UNITED STATES PATENT AND TRADEMARK OFFICE

APPLICATION NO.	FILING DATE	FIRST NAMED INVENTOR	ATTORNEY DOCKET NO.	CONFIRMATION NO.
10/670,985	09/25/2003	Jaime L. Rugnetta	279.607US1	4509

Office Action Summary

DETAILED ACTION

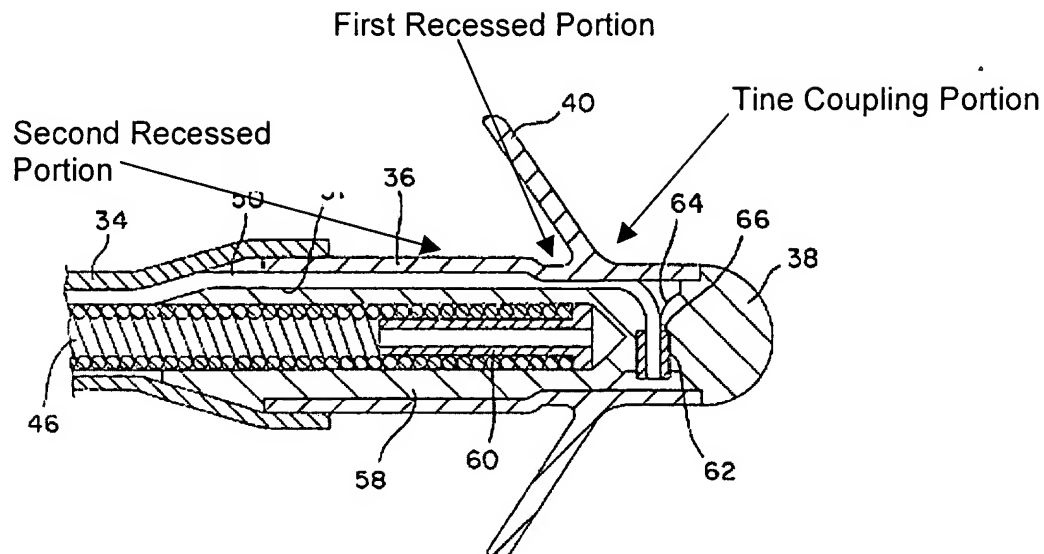
Huepenbecker et al. discloses a lead having at least one tine (40) coupled at the distal end thereof. The tines have a first position extended away from the lead body (as shown in Figure 4 reproduced below). In addition, although not explicitly stated, the tines necessarily have a second collapsed position because the tines are formed of a flexible material such that the tines fold/collapse against the lead body during insertion into the patient. The lead includes two recessed portions, as indicated on Fig. 4 reproduced below. The first recessed portion is longitudinally disposed between the tine coupling portion and the second recessed portion, as shown below. In addition, when the tines collapse during implantation, the first recessed portion would necessarily be recessed away from the bottom surface of the tine.

With respect to claim 4, it appears from Figure 4 that the cross-sectional area at the lead distal end (between electrode 38 and the tine- coupling portion) is approximately the same as the cross-sectional area of the tine coupling portion. Accordingly, the cross-sectional area of the tine coupling area is necessarily "less than 10% smaller" than the cross-sectional area of the lead distal end.

With respect to claim 7, Examiner considers spacer 34 shown on Figure 4 to be an "intermediate portion of the lead body." As shown in Fig. 4, the diameters of the

spacer 34, the first recessed portion, and the second recessed portion are each different from one another.

With respect to the rejection of claim 8 based on Huenpenbecker, the cross-sectional area of the first recessed portion is illustrated in Figure 4 as smaller than the cross-sectional area of the second recessed portion. As such, Examiner considers the first cross-sectional shape to be different from the second cross-sectional shape. In the alternative, Examiner notes that the 103 rejection above for claims 17-18 relate to modifying the first and/or second recessed areas to be non-circular (thus resulting in the first cross-sectional shape being different from the second cross-sectional shape).

**FIG. 5**

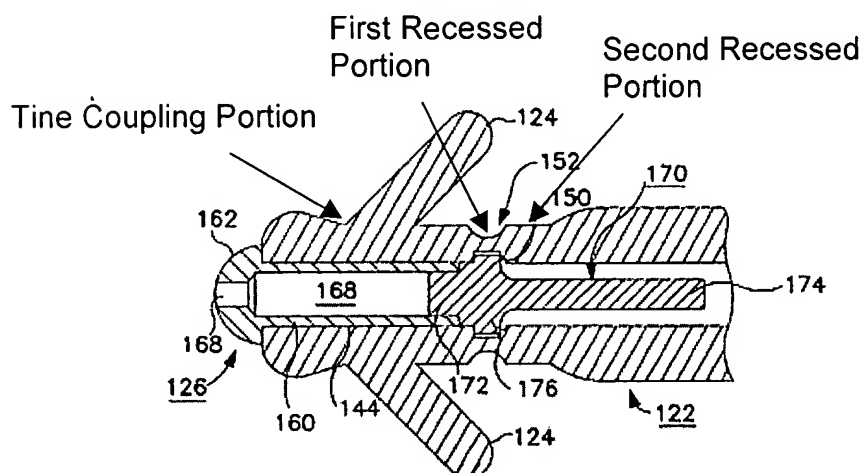
Laske et al. discloses a lead having at least one tine (124) coupled at the distal end thereof. The tines have a first position extended away from the lead body (as shown in Figure 5 reproduced below). In addition, although not explicitly stated, the tines necessarily have a second collapsed position because the tines are formed of a soft, pliant material such that the tines fold/collapse against the lead body during insertion into the patient (see col. 5, lines 23-37). The lead includes two recessed

portions, as indicated on Fig. 5 reproduced below. The first recessed portion is longitudinally disposed between the tine coupling portion and the second recessed portion, as shown below. In addition, when the tines collapse during implantation, the first recessed portion would necessarily be recessed away from the bottom surface of the tine.

With respect to claim 4, it appears from Figure 5 that the cross-sectional area at the lead distal end is slightly larger than the cross-sectional area of the tine coupling portion. Examiner considers the cross-sectional area of the tine coupling area to be approximately "less than 10% smaller" than the cross-sectional area of the lead distal end.

With respect to claim 7, Examiner considers tubular sheath 122 shown on Figure 5 to be an "intermediate portion of the lead body." As shown in Fig. 5, the diameters of the sheath 122, the first recessed portion, and the second recessed portion are each different from one another.

With respect to the rejection of claim 8 based on Laske, the cross-sectional area of the first recessed portion is illustrated in Figure 5 as smaller than the cross-sectional area of the second recessed portion. As such, Examiner considers the first cross-sectional shape to be different from the second cross-sectional shape. In the alternative, Examiner notes that the 103 rejection above for claims 17-18 relate to modifying the first and/or second recessed areas to be non-circular (thus resulting in the first cross-sectional shape being different from the second cross-sectional shape).
